NSW Planning Assessment Commission

Coalpac Consolidation Project Review: Main Report

14 December 2012

Figure 6-3: 50m Standoff Distance (Source: OEH, letter dated 6 November 2012, Figure E1.1)

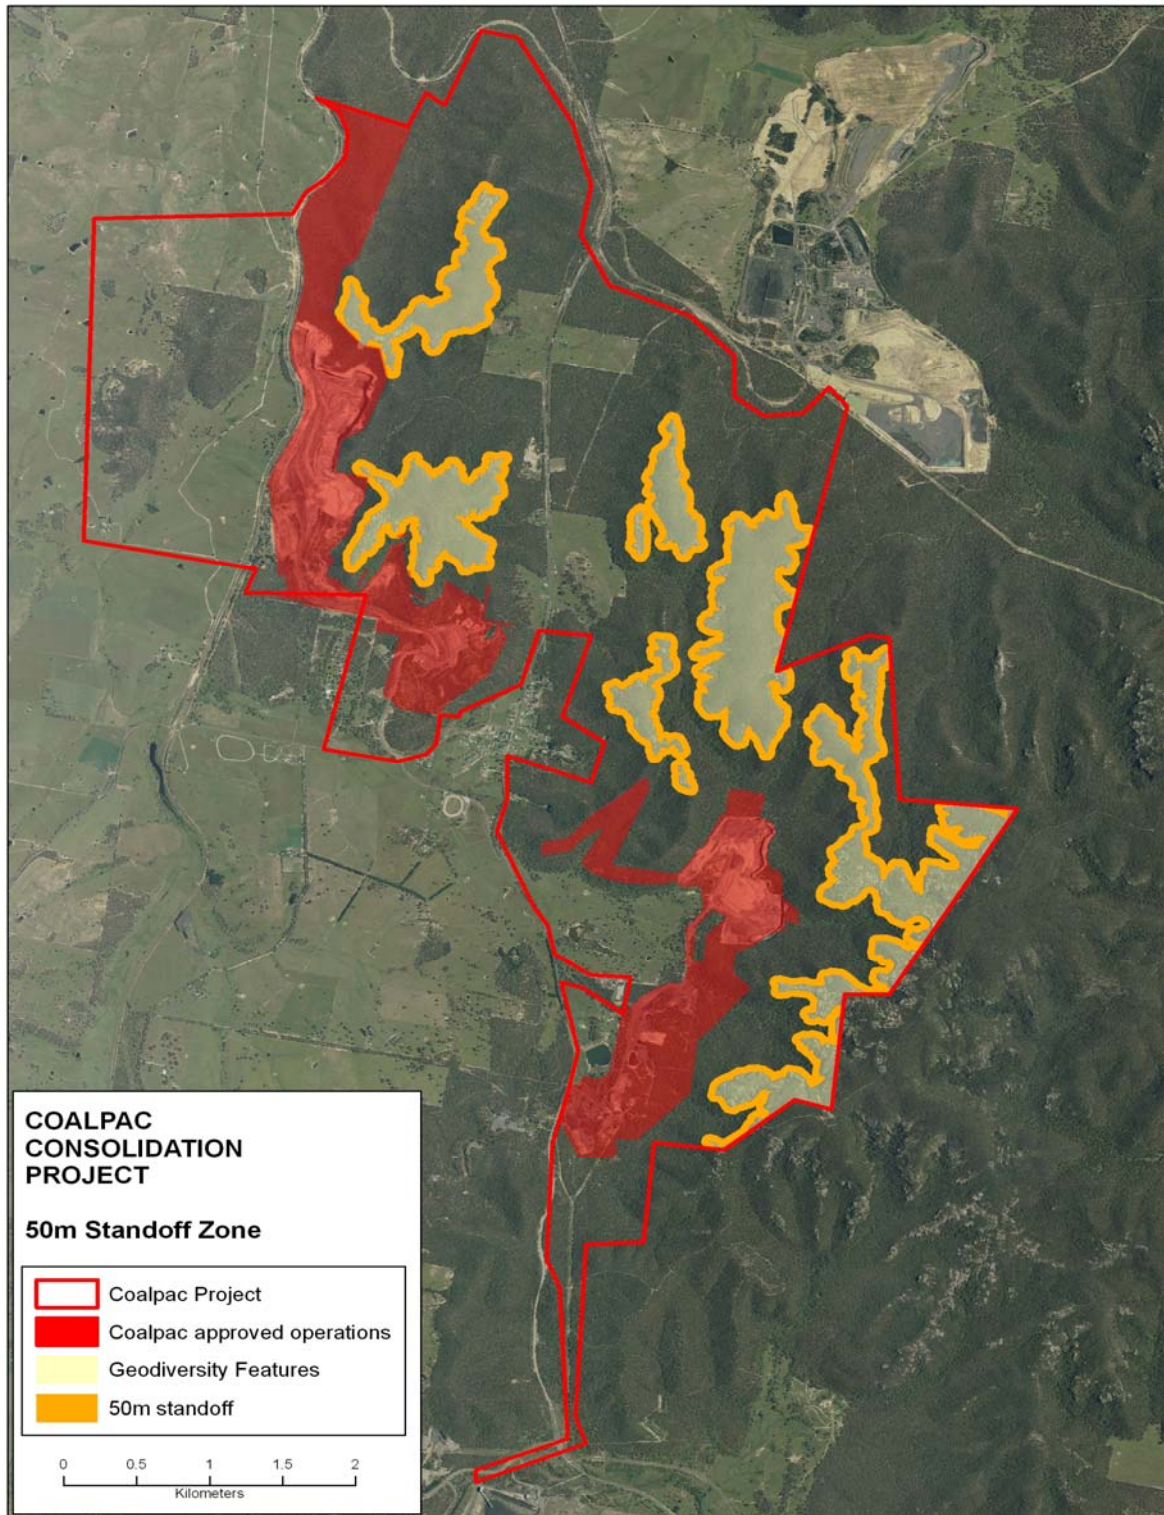
The 50m setback distance is referred to frequently in the EA (it is the only setback distance referred to in Appendix F, which is the relevant Appendix for consideration of stability and subsidence). However, the main report (EA p.45) refers to a standoff zone of only 20m from any significant exposed outcrop or formation that does not fall under the categorization of '*pagodas or significant sandstone cliffs or escarpments*'. The location of the '*sandstone pagodas and escarpments*' within the project area is outlined in Figure 5 of the EA.¹⁶⁴ However, there are some differences of detail between Figure 5, and Figure 6-3 in this report. The map in Figure 5 of the EA is of relatively poor quality. The map in Figure 6-3 over the page was produced by OEH using sophisticated equipment.¹⁶⁵ It should also be noted that the Colong Foundation asserts that the pagodas and escarpments have not been accurately mapped in the EA.¹⁶⁶

Figure 6-4: All Standoff Distances (Source: OEH, letter dated 6 November 2012, Figure E1.2)

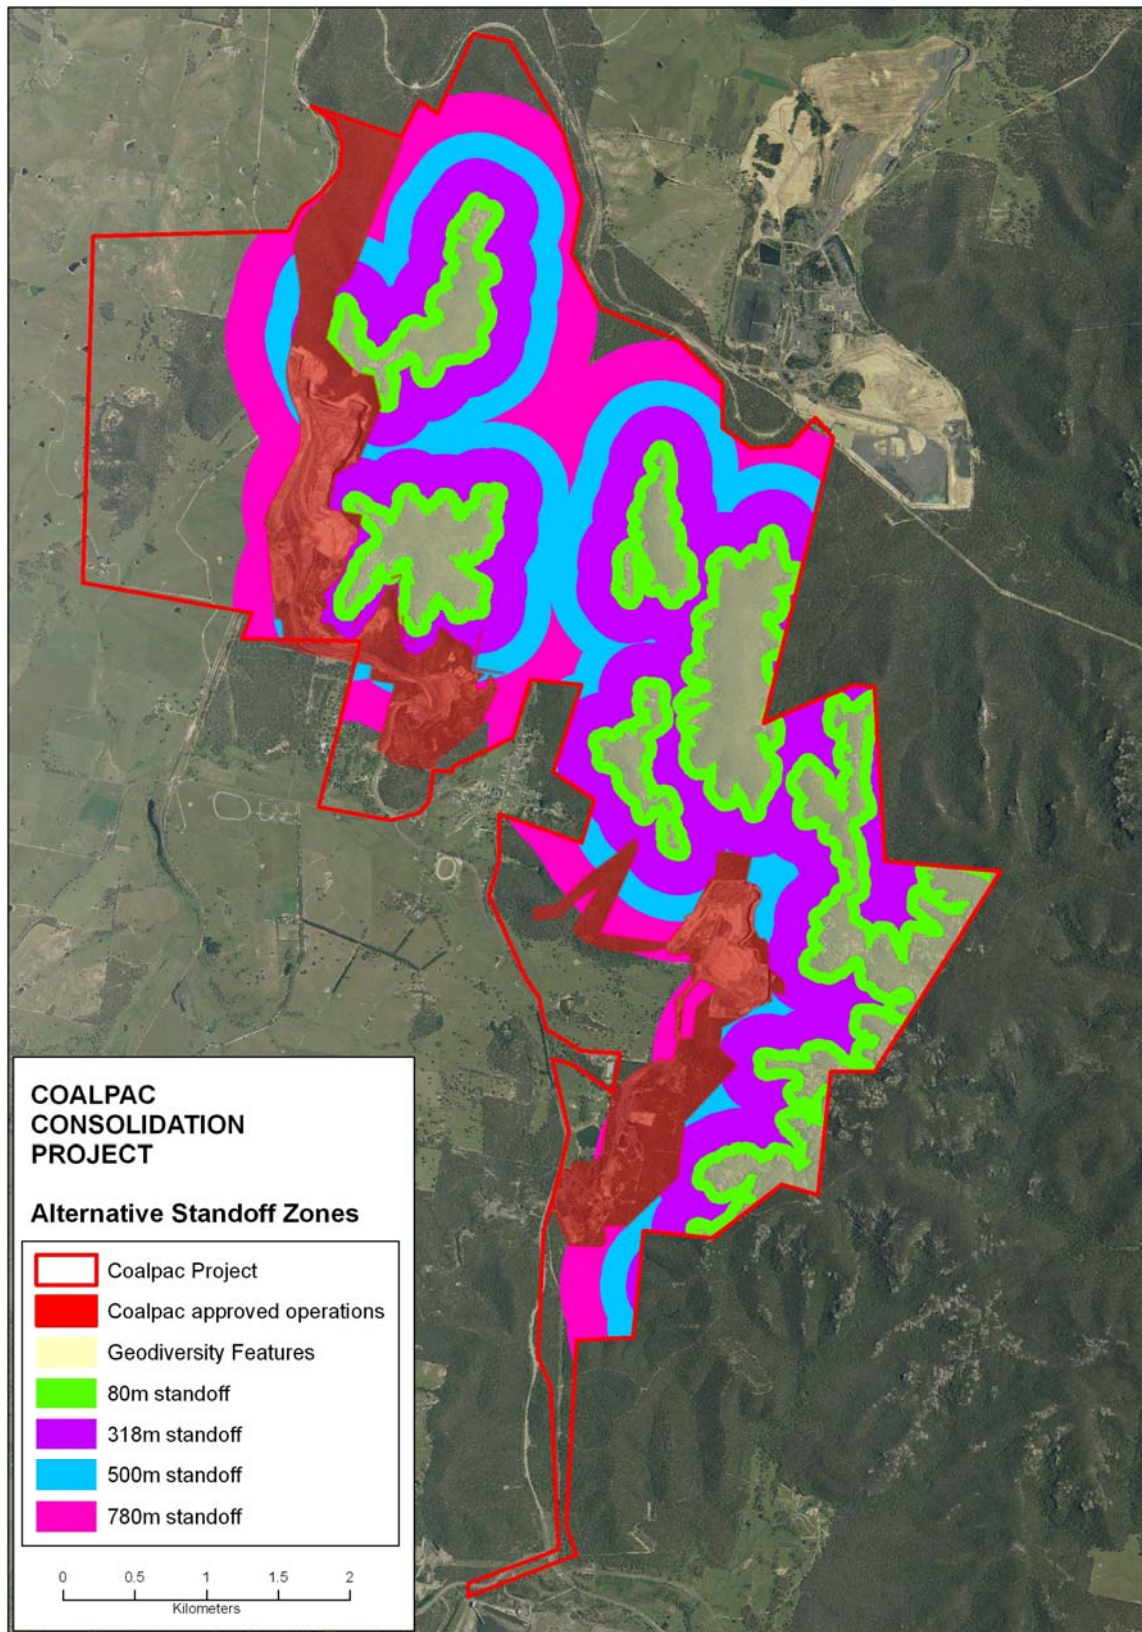
- Mapping increasing setback distances from the pagodas and cliff lines to meet essential habitat requirements for listed threatened species demonstrates just how much the pagodas and cliff lines divide up the project area. A full 500m setback (as per TSPD requirements) would eliminate much of the open-cut (see Figure 6-4 over the page). This suggests that open-cut mining may not be the optimum use for this area which has such high scenic, conservational and recreational value;

Recommendation 47: The Commission recommends that to provide adequate protection for threatened species and other fauna that use the pagoda landform, a minimum setback distance of 300m be maintained from the open-cut highwall to the pagodas and the escarpments.
